Form 3160-5
(June 2019)

SUNDRY NOTICES AND REPORTS ON WELLS
Do not use this form for proposals to drill or to re-enter an abandoned well. Use Form 3160-3 (APD) for such proposals.

8. Well Name and No.
GREEN DRAKE 16 FED COM/509H

EOG respectfully requests an amendment to our approved APD for this well to reflect the following changes:

C-102

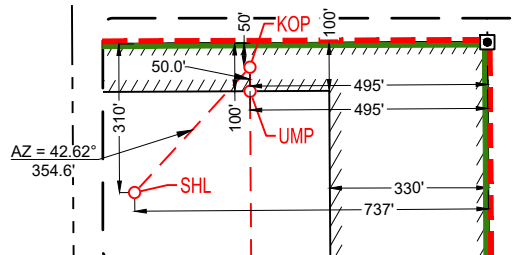
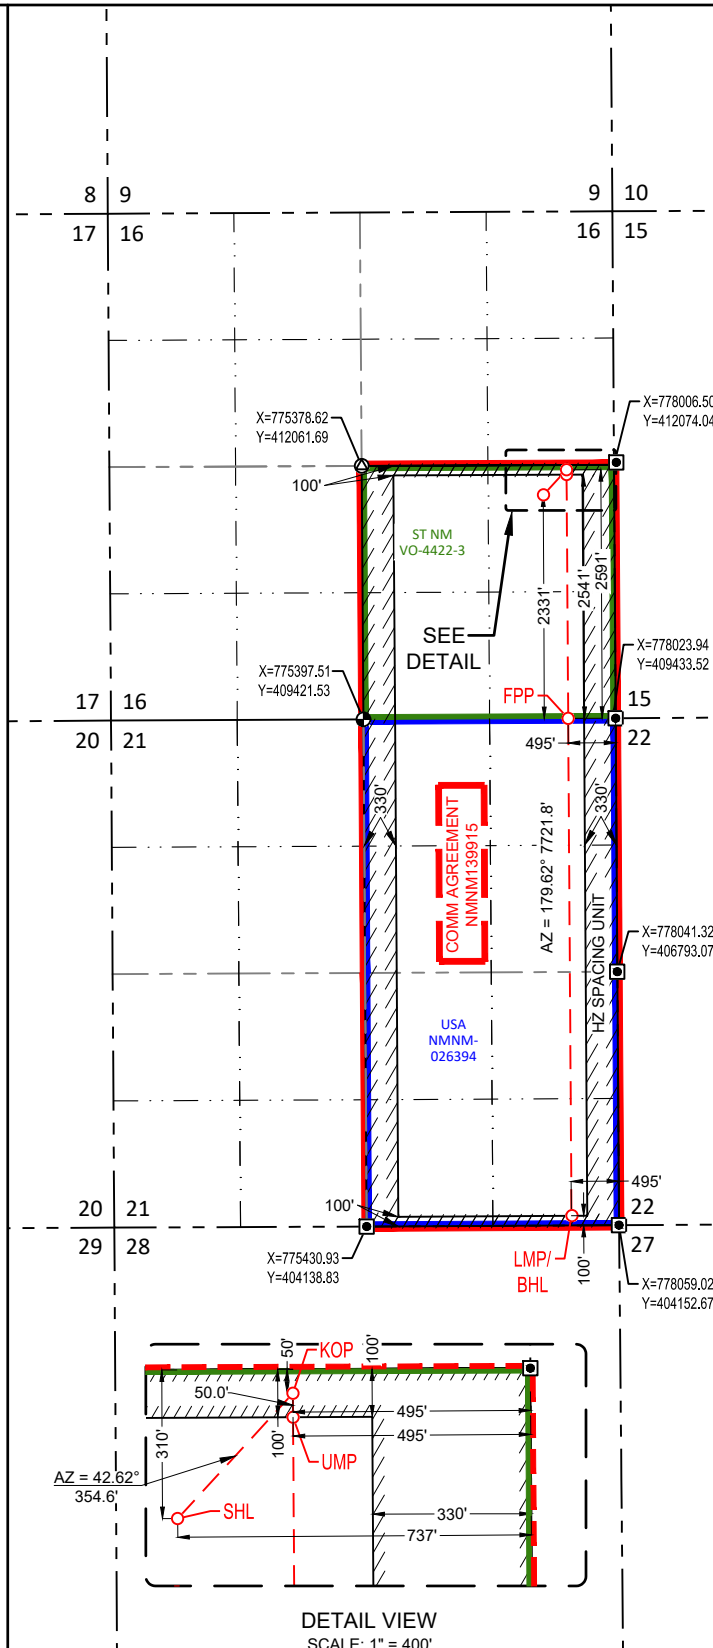
- Green Drake 16 Fed Com 753H (FKA 509H) API #: 30-025-51092
- Change name from Green Drake 16 Fed Com 509H to Green Drake 16 Fed Com 753H.
- Change SHL from T-25-S, R-33-E, Sec 16, 2137' FSL, 1401' FWL, LEA Co., NM, to T-25-S, R-33-E, Sec 16, 2331' FSL, 737' FEL, LEA Co., N.M.
- Change BHL from T-25-S, R-33-E, Sec 21, 100' FSL, 680' FWL, LEA Co., NM, to T-25-S, R-33-E, Sec 21, 100' FSL, 495' FEL, LEA Co., N.M.

Update the Pool as reflected in the C-102.

Revised Wellbore

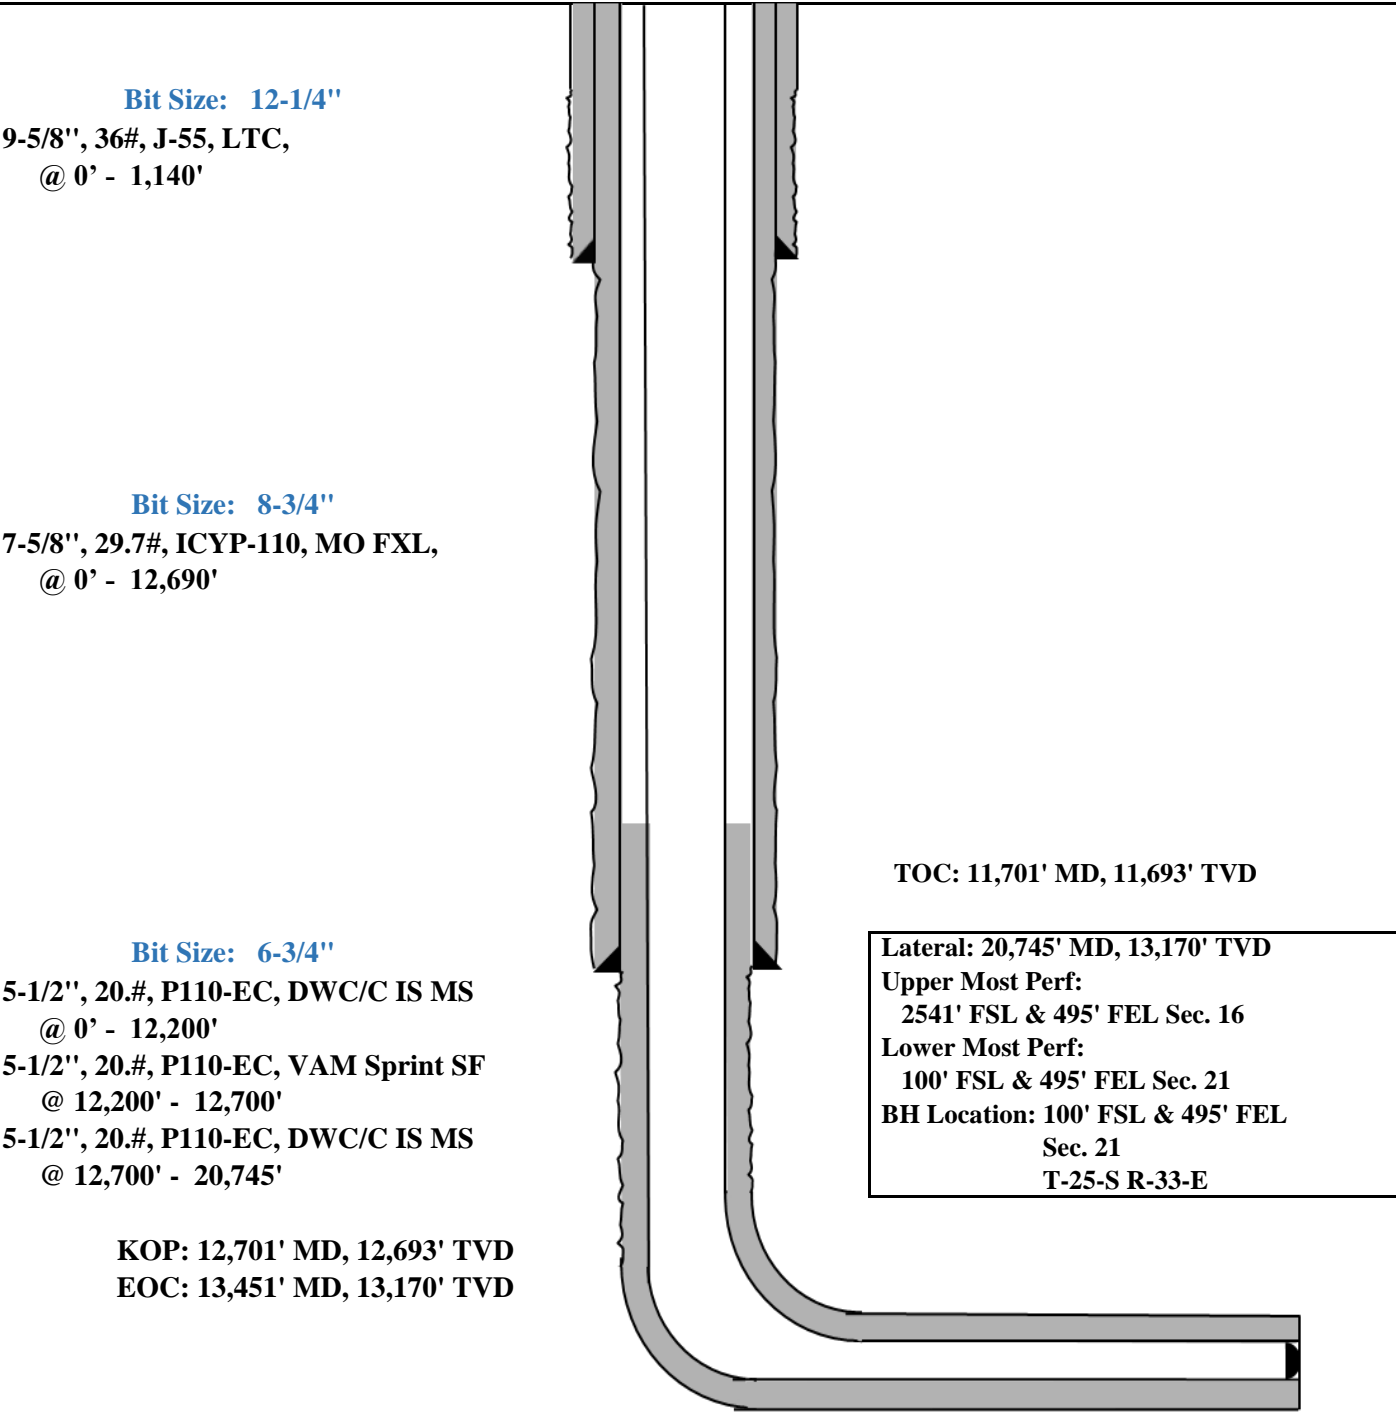
EOG requests variance from minimum standards to pump a two stage cement job on the 7-5/8" intermediate casing string with the first stage being pumped conventionally with the calculated top of cement at the Brushy Canyon (9,007') and the second stage performed as a 1000 sack bradenhead squeeze with planned cement from the Brushy Canyon to surface. If necessary, a top out consisting of 100 sacks of Class C cement + 3% Salt + 1% PreMag-M + 6% Bentonite Gel (2.30 yld, 12.91 ppg) will be executed as a contingency. Top will be verified by Echo-meter.
